MEETING MINUTES

A. **NOI-2025-02:** Notice of Intent at 391 North Main Street (Assessor's Parcel ID 13-23-0) for the dredging of Blackmon Pond to remove sediment as well as other park improvements subject to the Wetlands Protection Act 310 CMR 10.00 and local wetland bylaws Chapter 424 Wetlands Protection. Applicant: Town of East Longmeadow, 60 Center Square, East Longmeadow, MA 01028 Continued from 10/8/2025)

Re: **NOTICE OF INTENT PERMIT APPLICATION – RESPONSE TO COMMENTS FILE No. 150-0476**
Heritage Park, 391 North Main Street and Gates Avenue, East Longmeadow, MA 01028
Assessors map and block number: 13-23, 12B-23, 12B-61-203

Heritage Park
391 North Main Street
East Longmeadow, MA
01028

EXISTING CONDITIONS
001

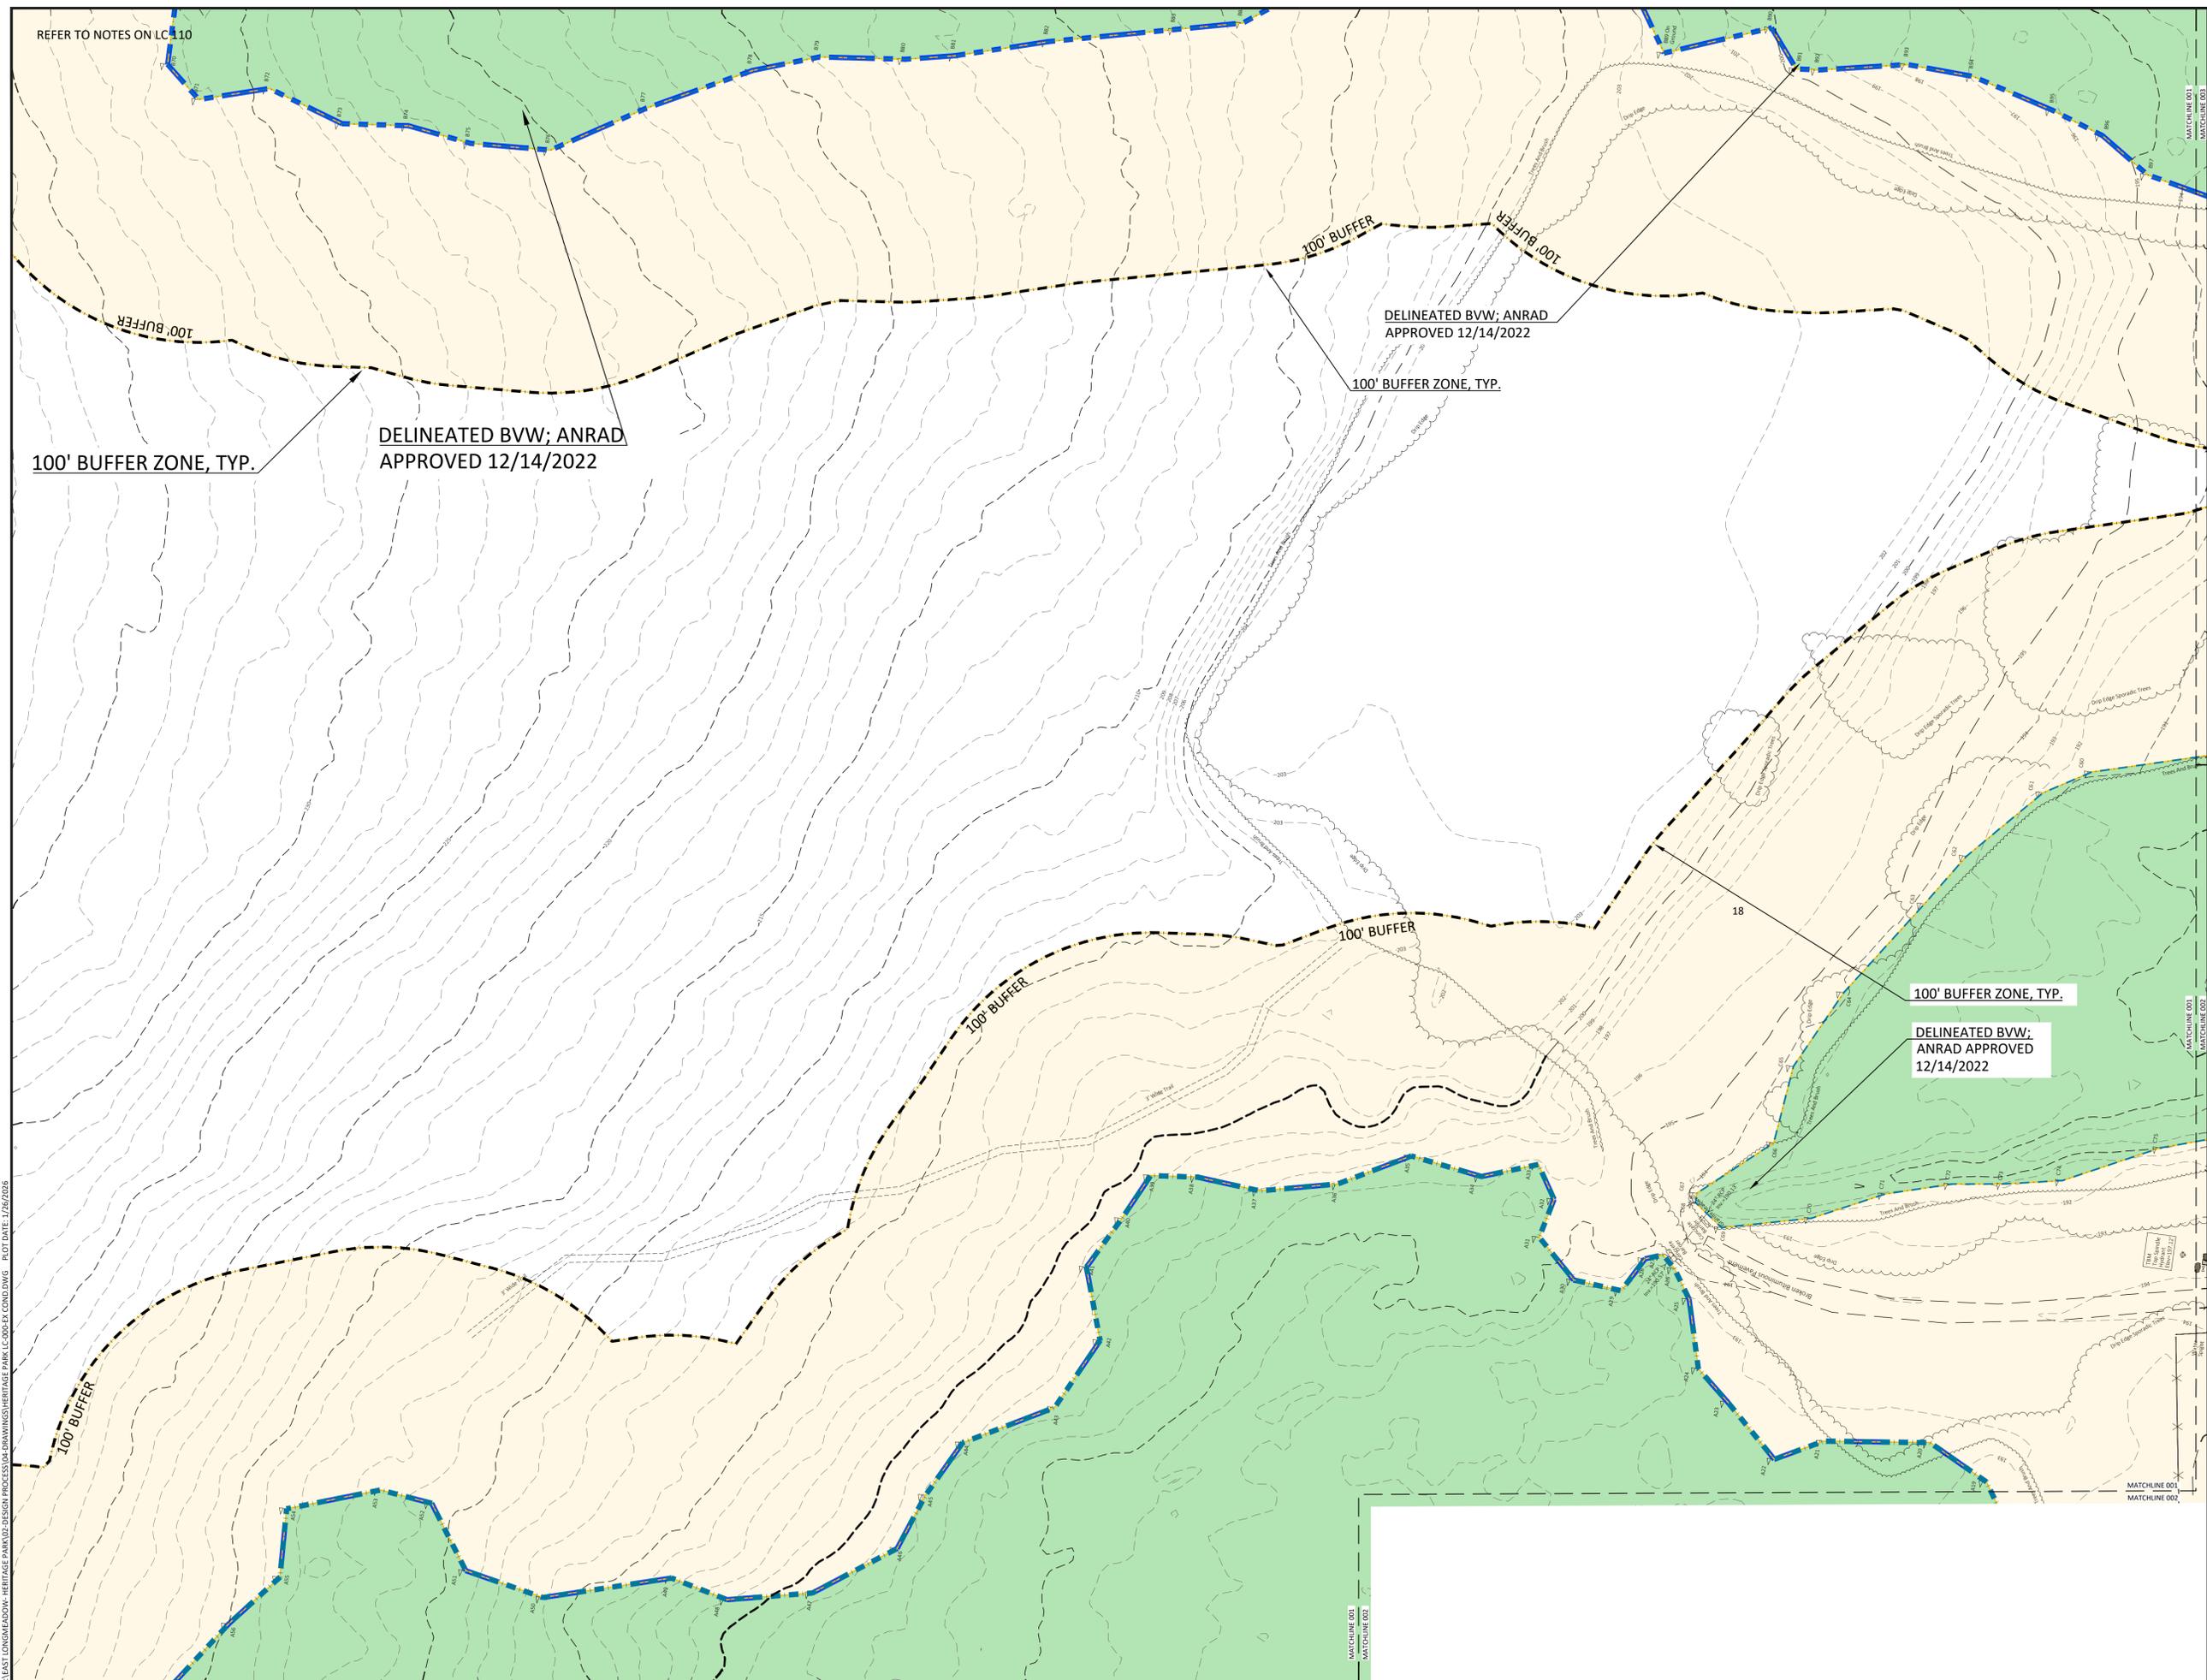
1. *Plans should use different colors for the BVW and open water.*

Revised Existing Conditions Sheets LC-000, LC-001, LC-002, and LC-003 are enclosed with the BVW depicted as a green shading and the LUWW depicted as a blue shading. The callouts to these areas have also been revised to label the type of wetland resource area for clarity.

LC-113

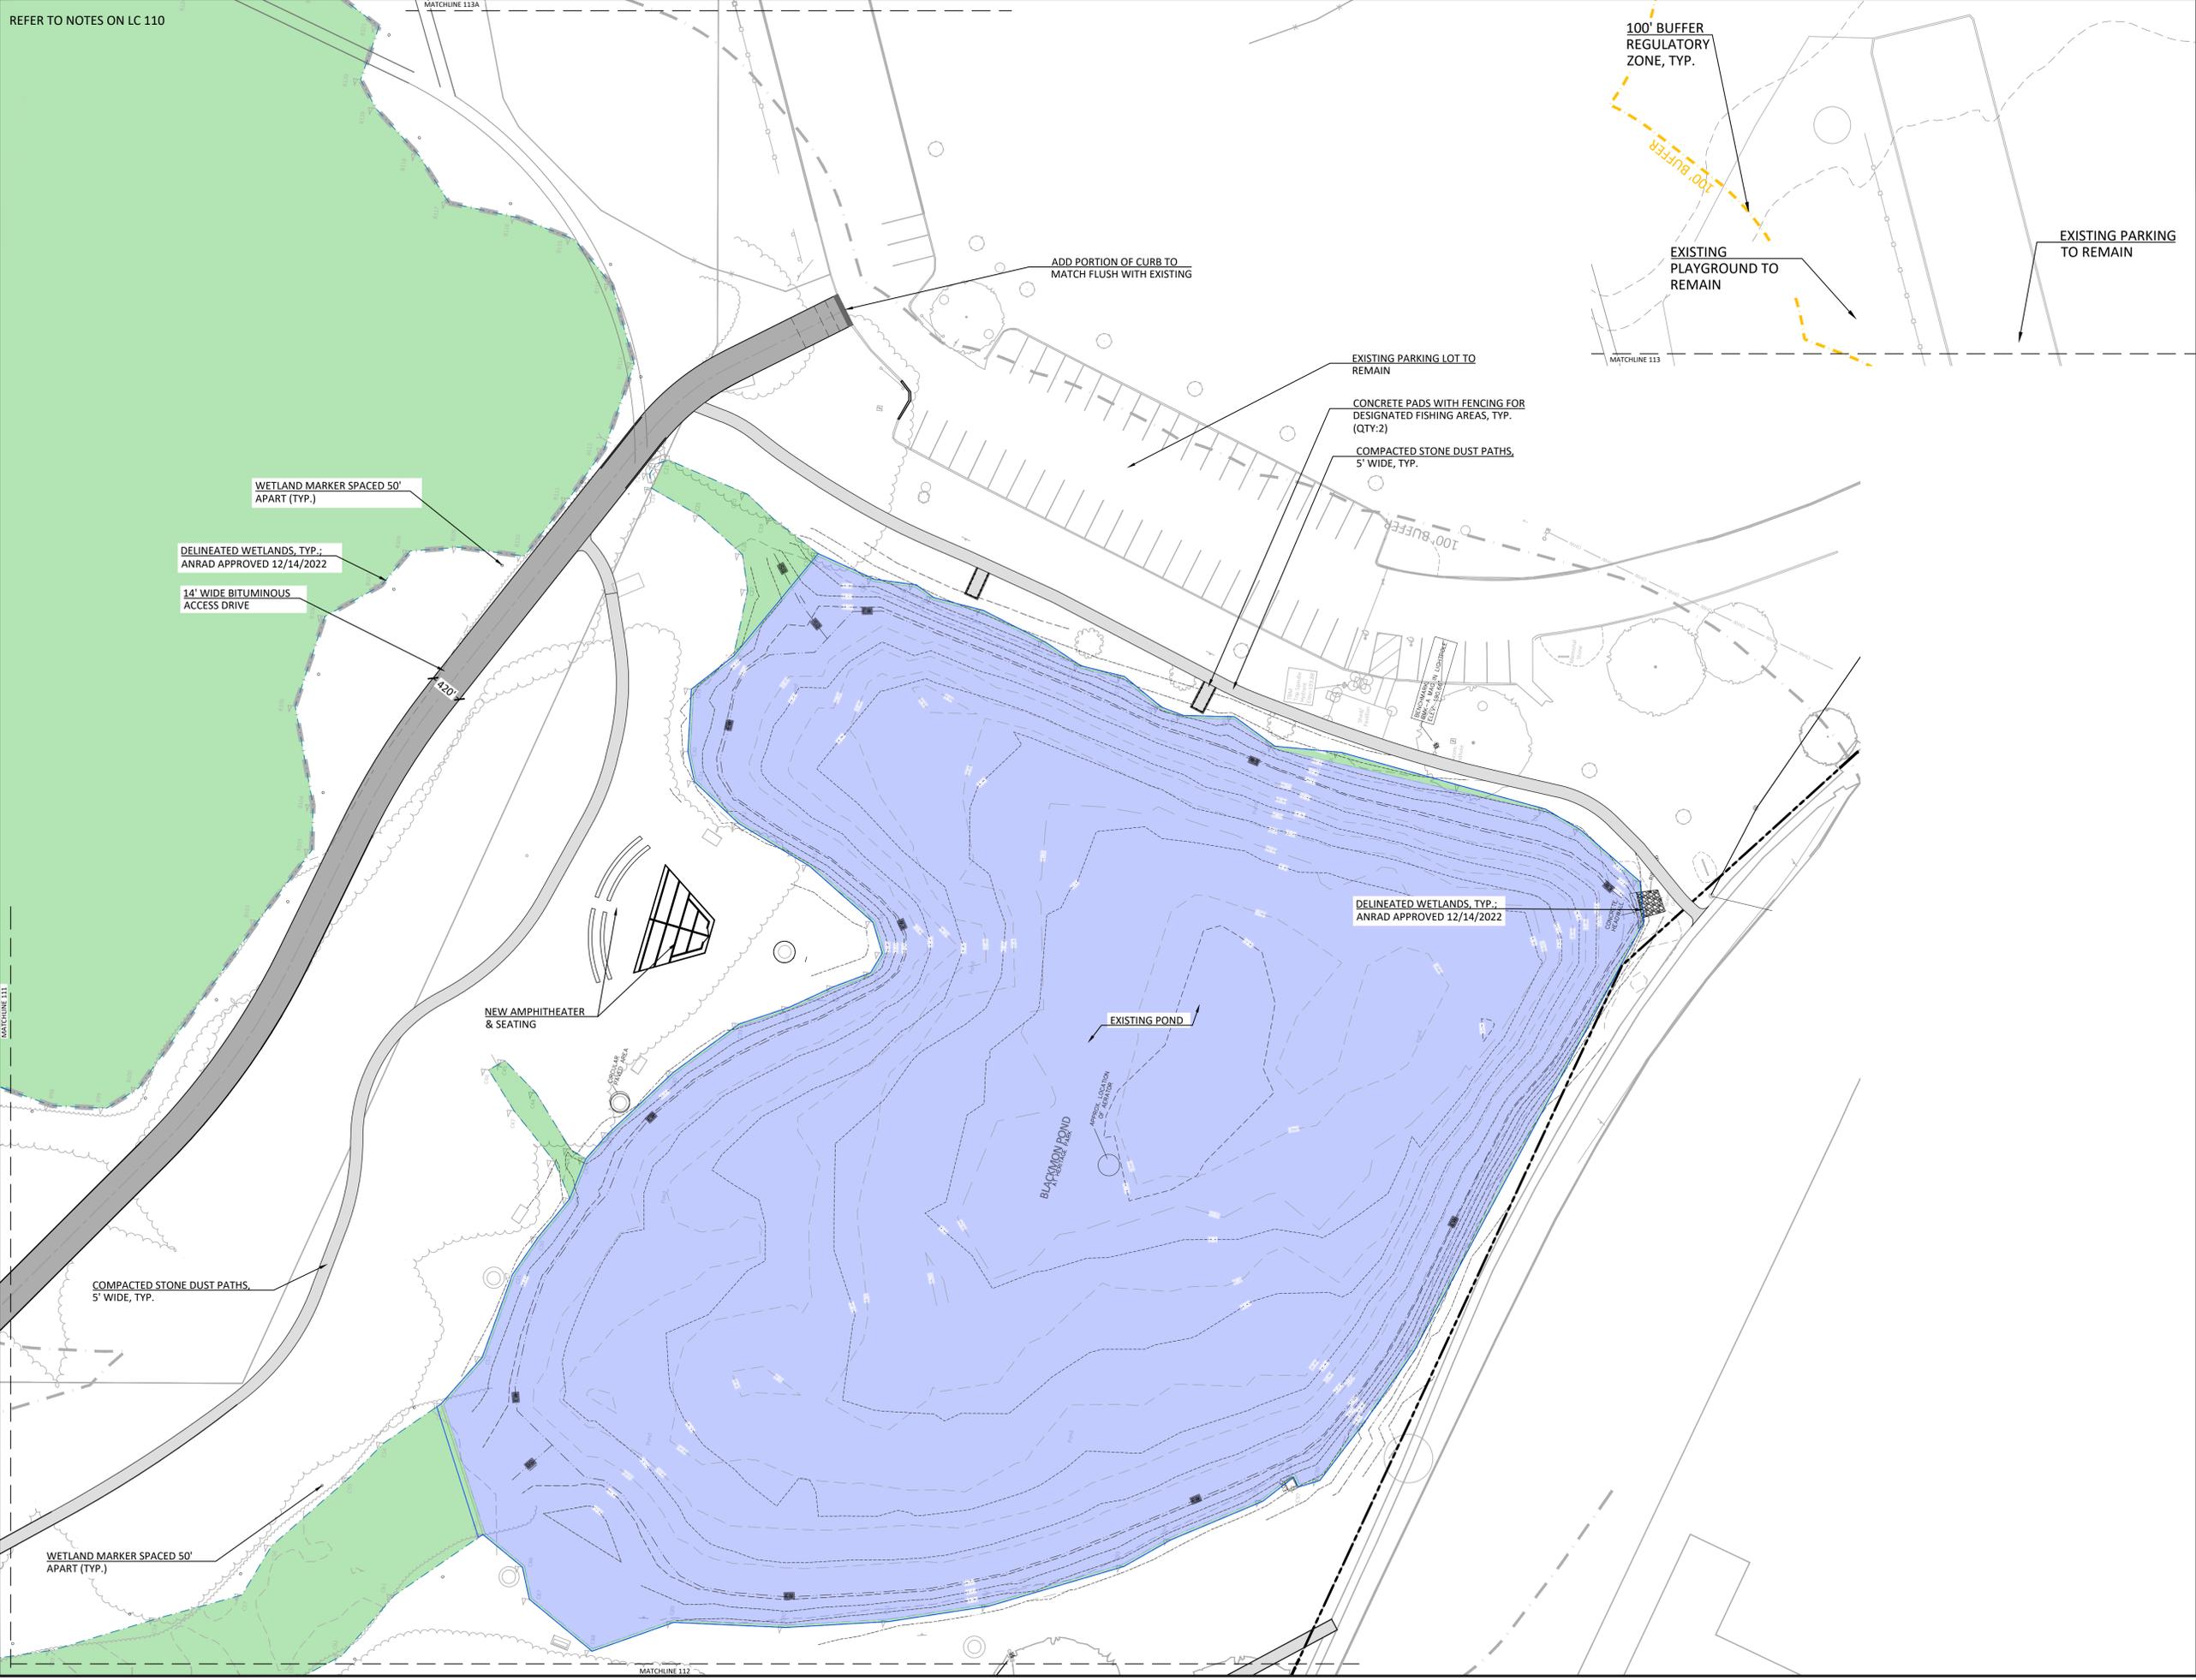
2. *Permanent Wetland markers should be installed no more than 50 feet apart along Wetland boundaries to prevent future encroachment or dumping of lawn clippings/leafy debris.*

Sheet LC-111, LC-112, and LC-113 have been revised to include wetland markers in areas where proposed improvements are planned less than 100 feet away from Bordering Vegetated Wetland areas. The wetland markers are proposed to be 6" by 6" wooden posts with wetland signage, as shown on the revised Sheet LC-506, Detail 8. The markers are placed at intervals of 50 feet. There are a total of 80 markers proposed.
